CROSSROADS MIXED USE FILING NO. 2

CONSTRUCTION PLANS

V3_Construction Drawings_comments.pdf Markup Summary

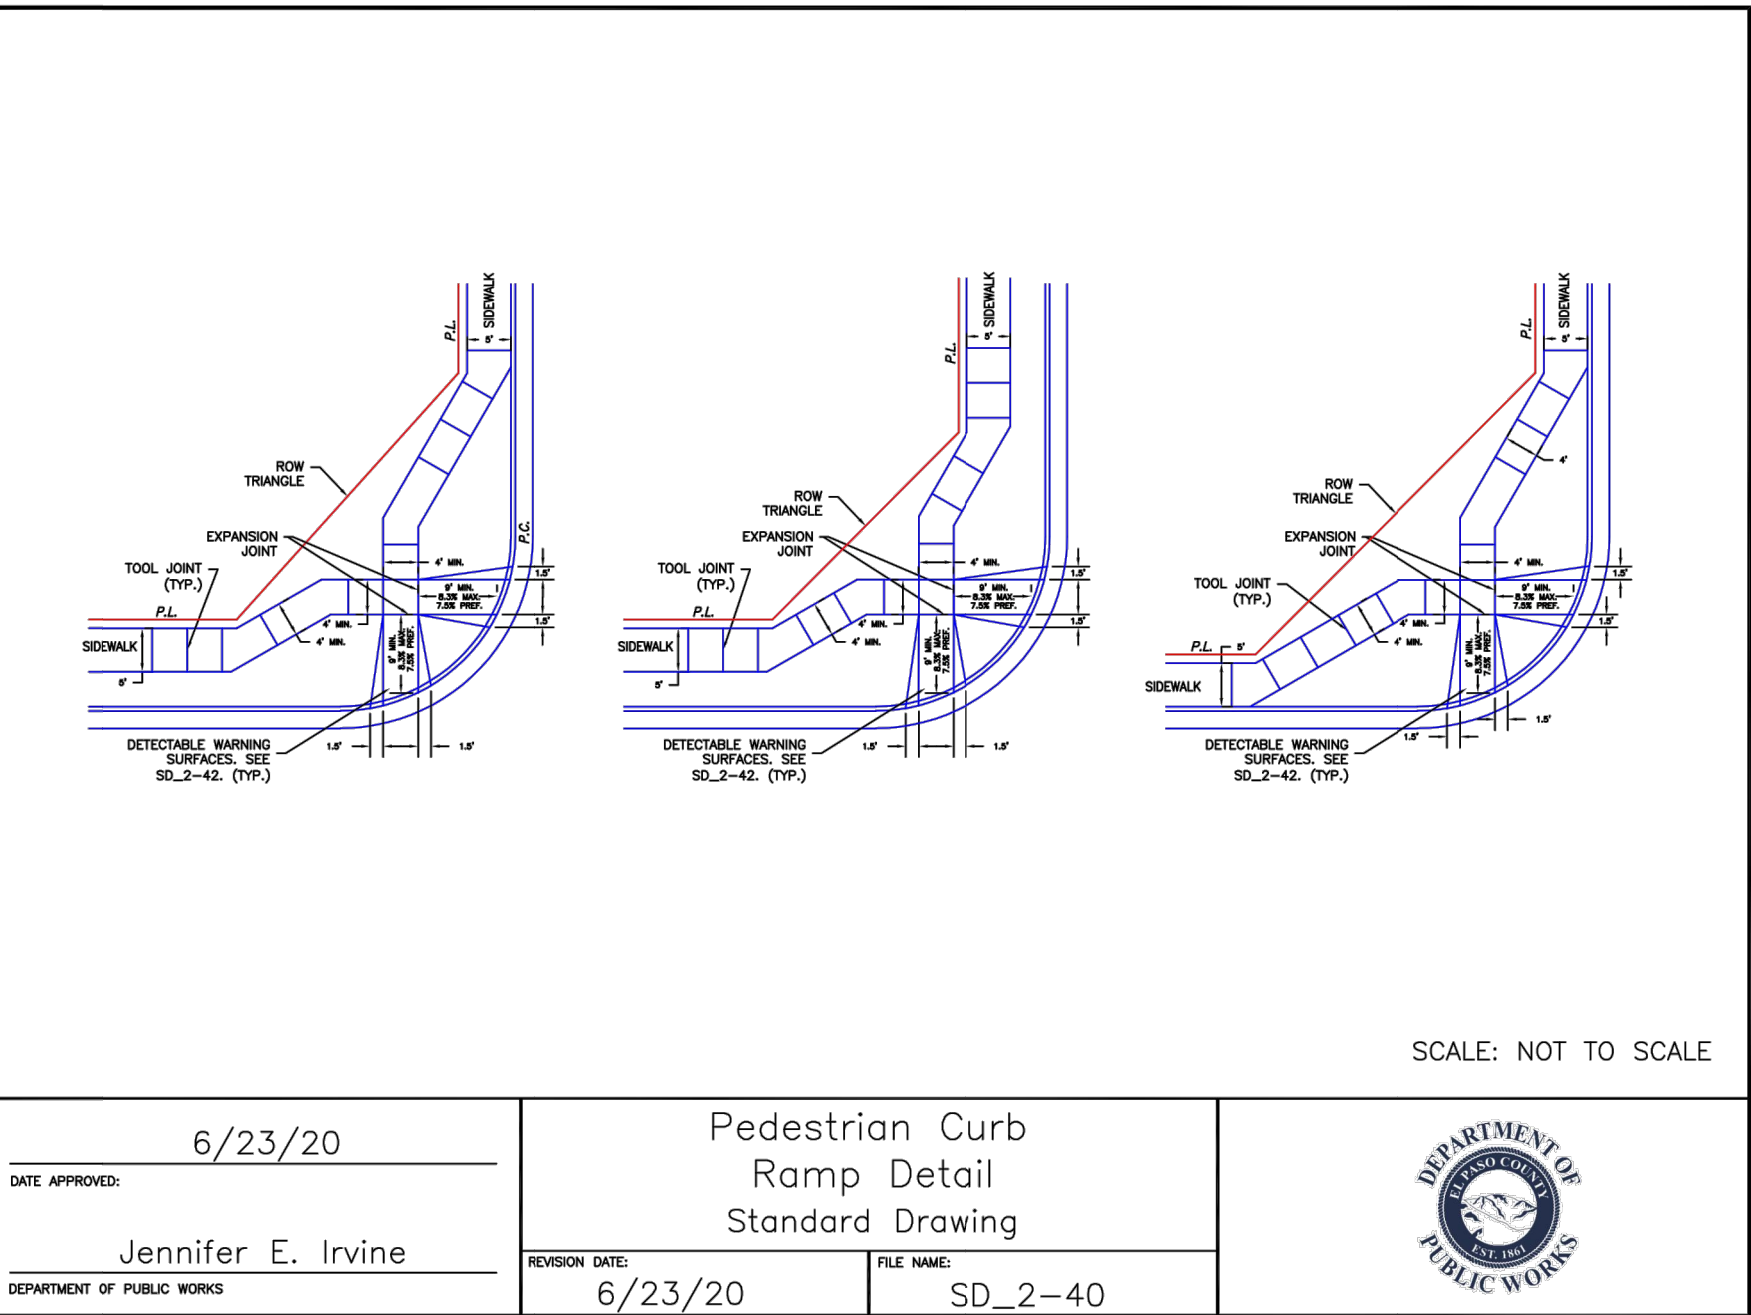
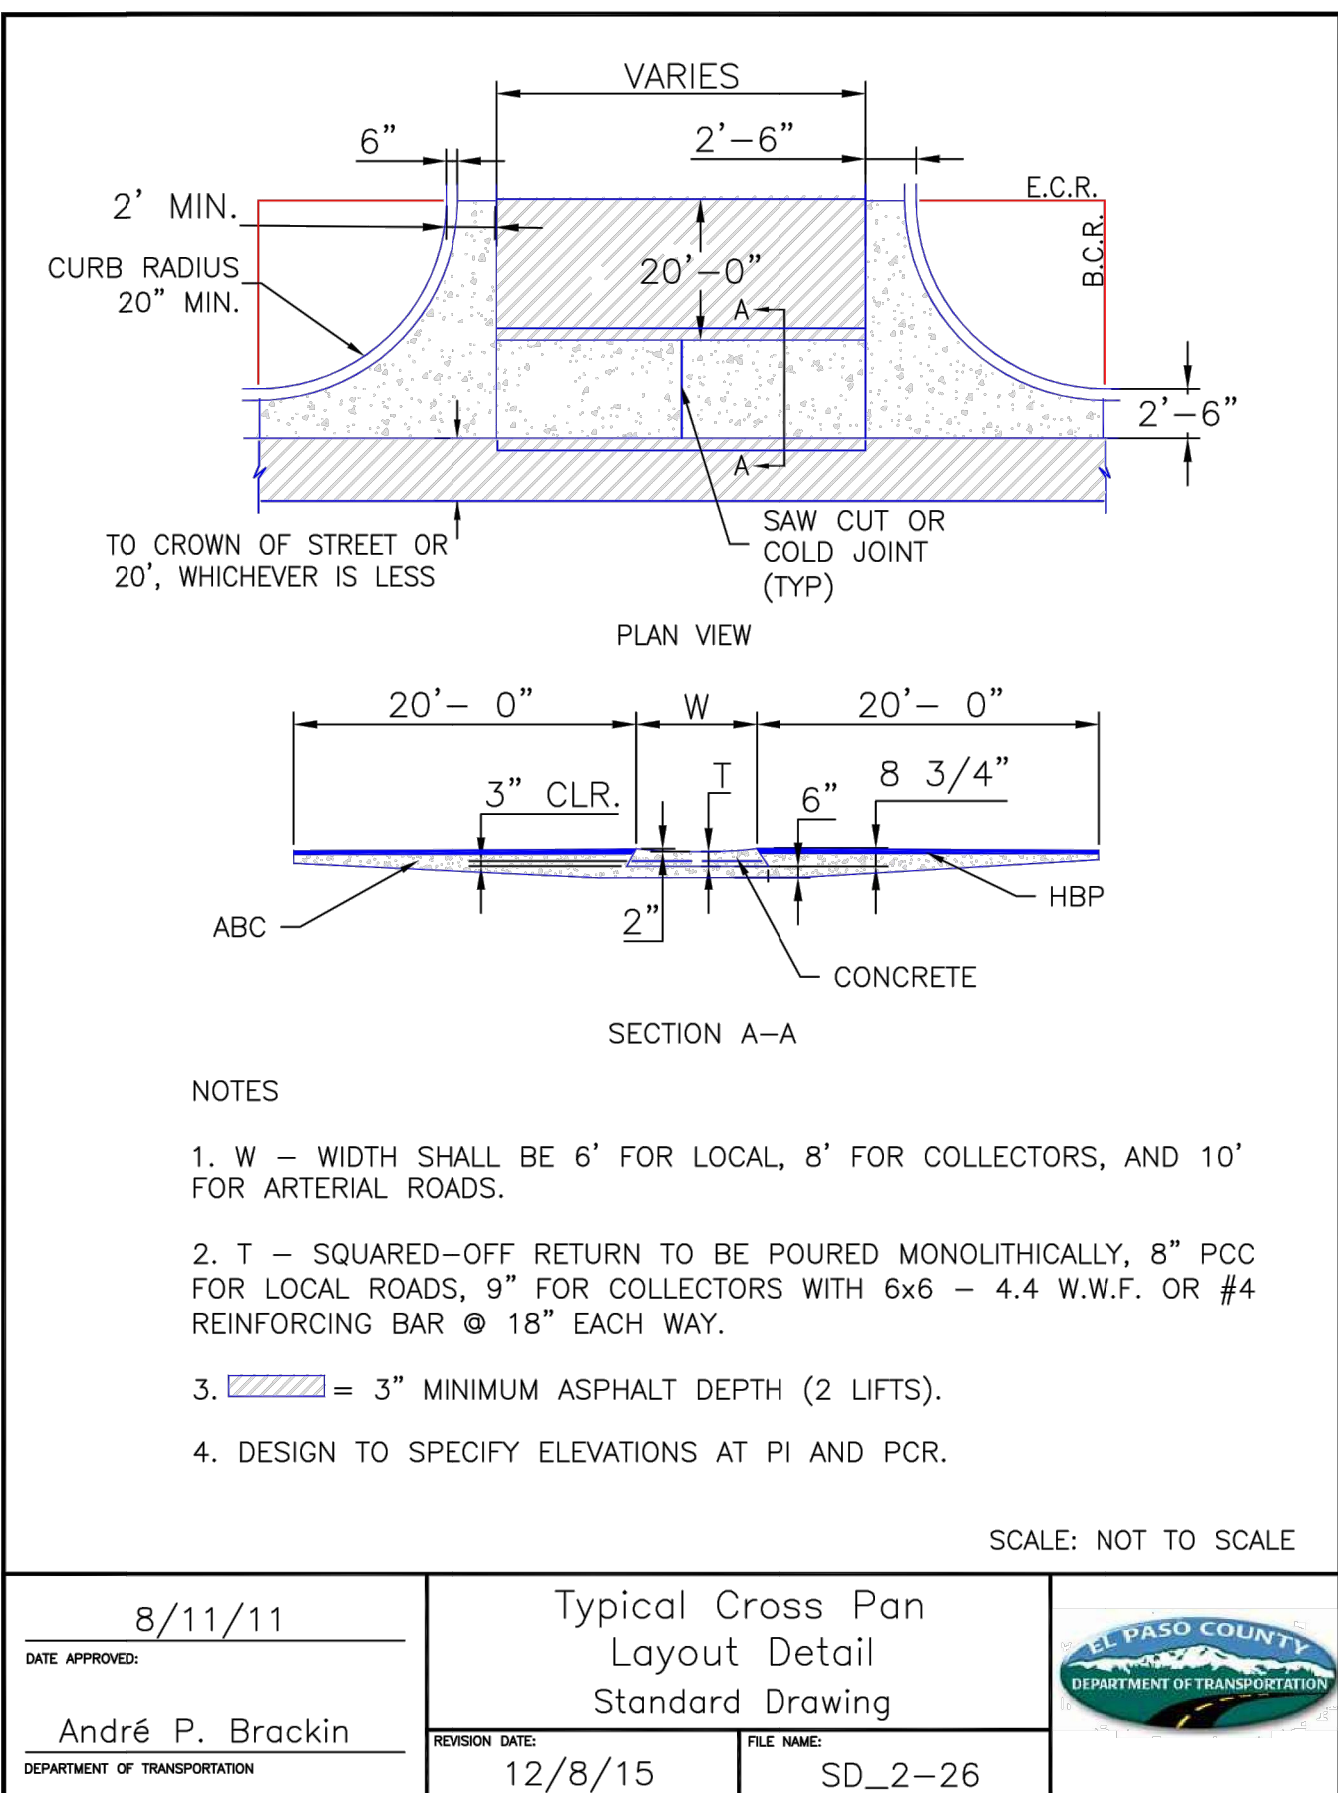
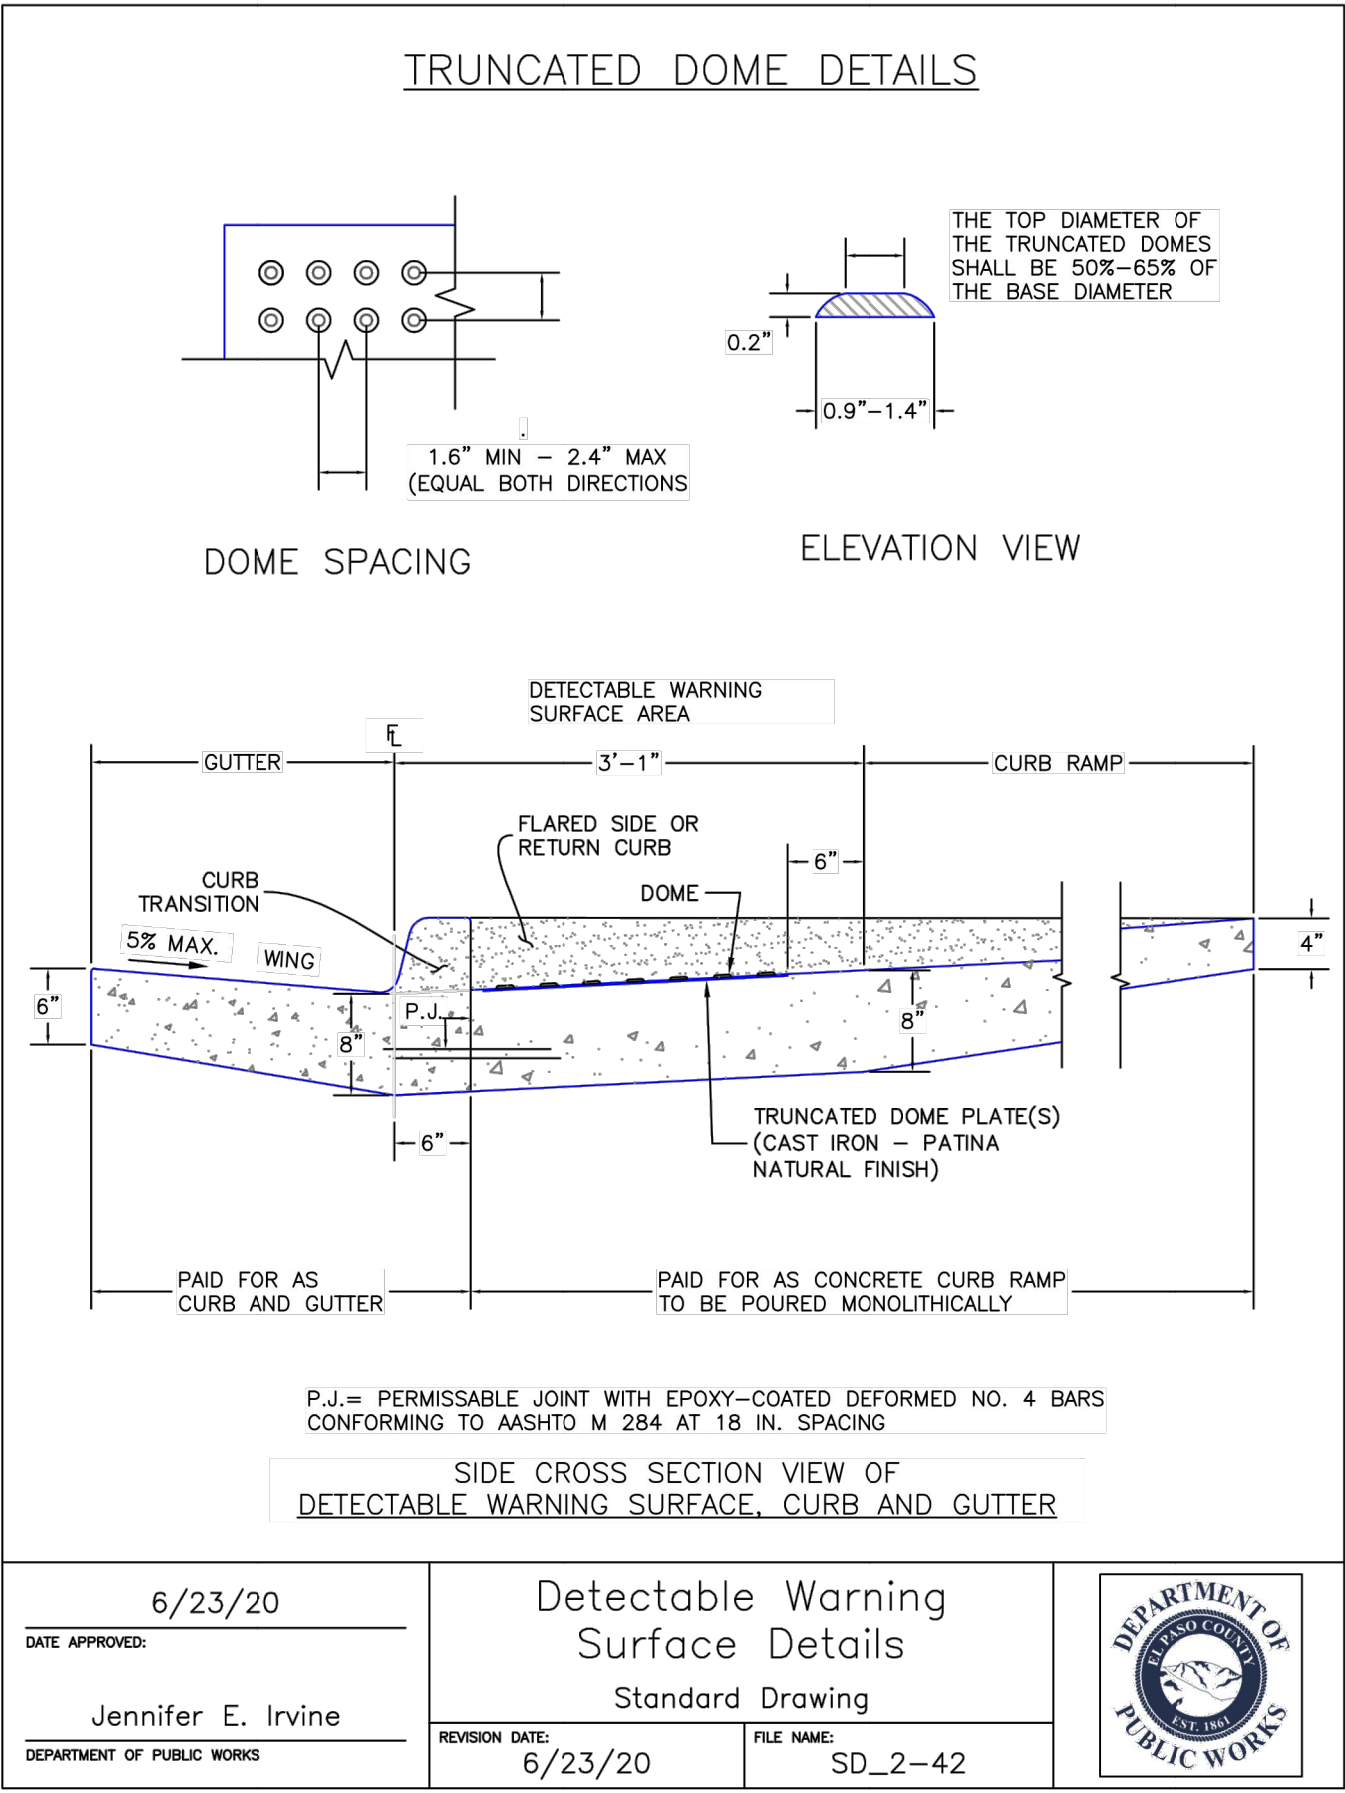
Unresolved from review 1 and 2. Update cross section to provide sidewalk on both sides per the approved deviation request filed under PCD File No SP2011.

Deviation was denied. Please update to include sidewalk on appropriate places.

Drawings have been updated to include the sidewalks on each side as in appropriate places with ramps.

Unresolved from review 1 and 2. Update cross section to provide sidewalk on both sides per the approved deviation request filed under PCD File No. SP2011.

Deviation was denied. Please update to include sidewalk on appropriate places.
